XPOLogistics Manufacturing

Control Line Valve Replacement Instructions

November 1, 2018

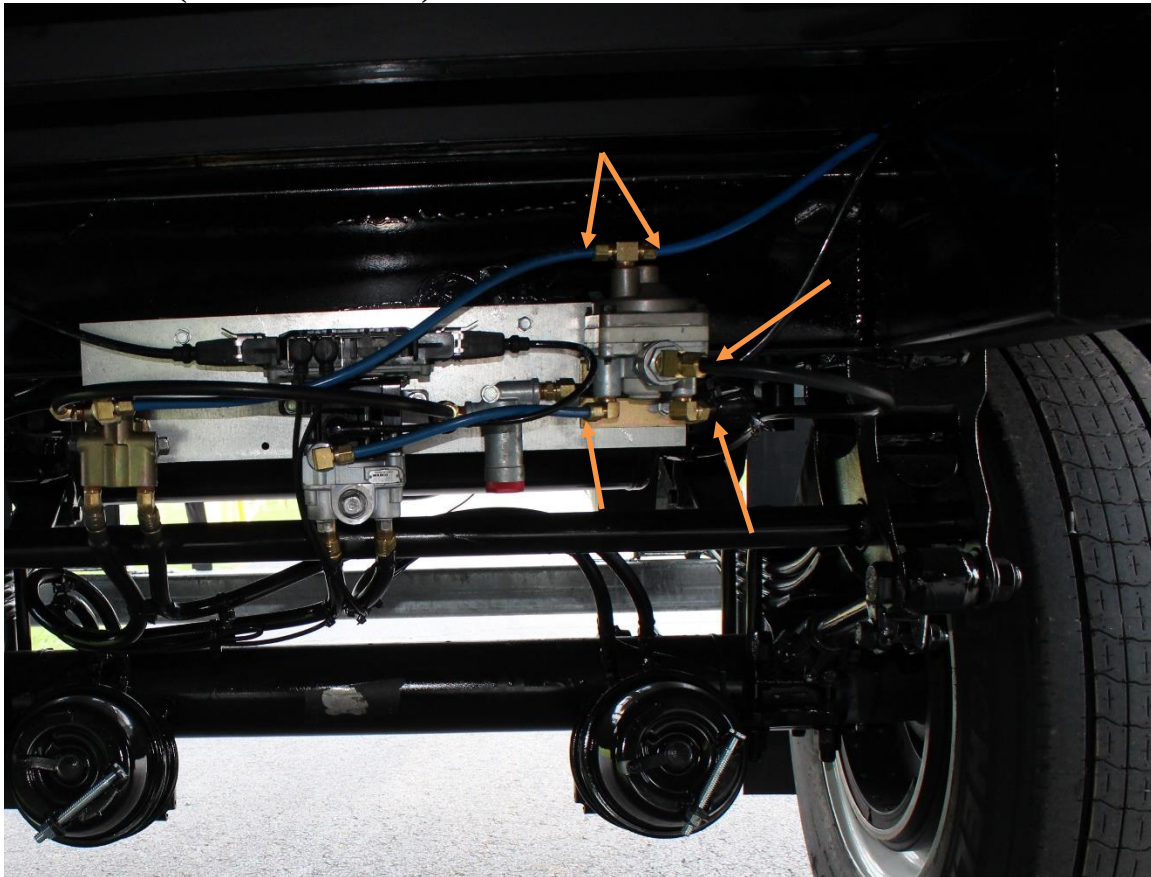
On some 2017 and 2018 units the control line valve will need to be replaced with one that does not have a “Dolly Port”. The valve configuration is the same but the ones that have “Dolly Port” marked on the side of the valve include a special orifice designed to slow down the air flow. The part number for the new valve is 7045000 (Sealco #110580). This change only applies to trailers with ABS. The valves with the “Dolly Port” are to continue to be used on trailers that do not have ABS.

1. Disconnect the air lines. There are a total of five air lines that need to be removed from the valve (3 blue and 2 black).

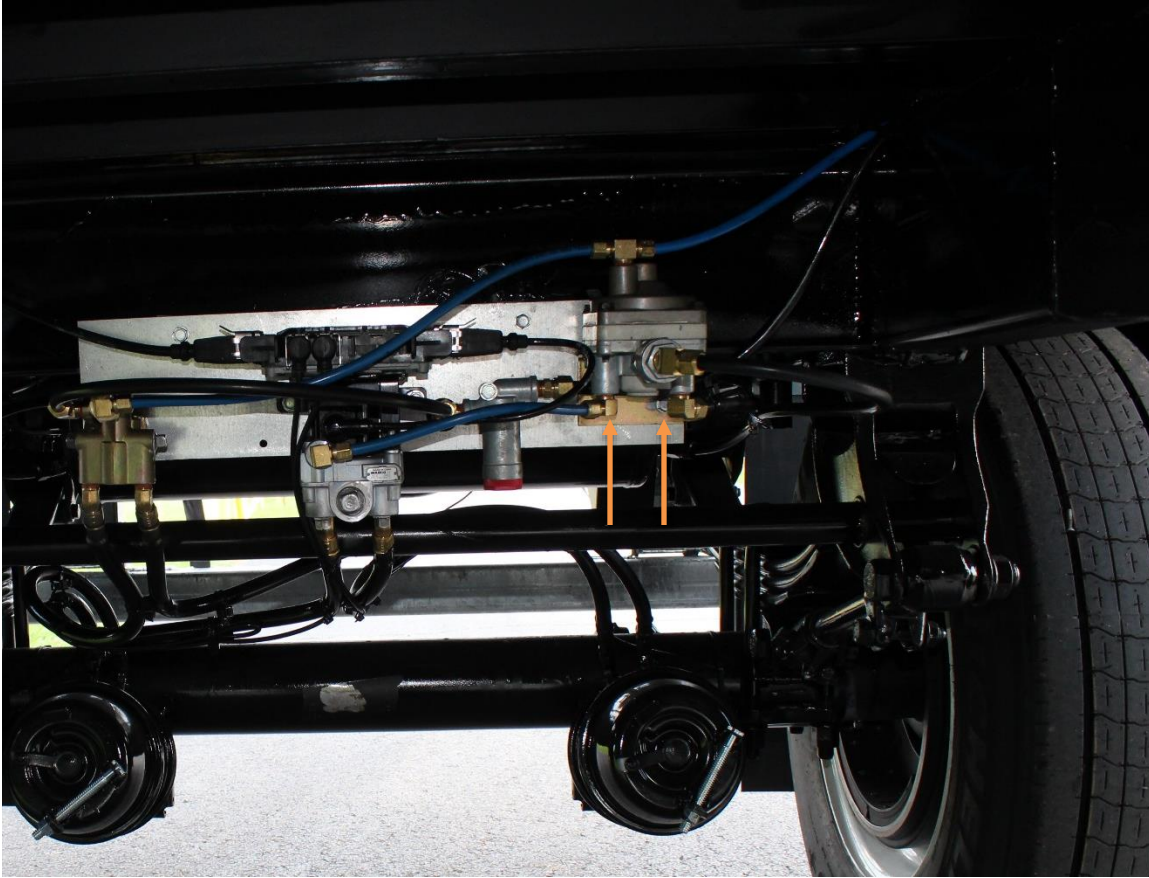
2. Remove the two bolts holding the valve bracket to the air kit plate.

3. Remove the fittings from the old control valve. Install them on the new valve in the same configuration they were in on the old valve.
4. Install the new valve onto the air kit plate in the same location as shown in the picture in Step 2. The valve is originally installed using self-tapping bolts. If the threads are stripped or the bolts do not go back in correctly, drill out the holes and use 5/16-18 x 1-1/2" bolts with Nylok nuts.
5. Connect the air lines back in the same locations as shown in the picture in Step 1. Be sure to use new ferrels in the Nylon tubing.
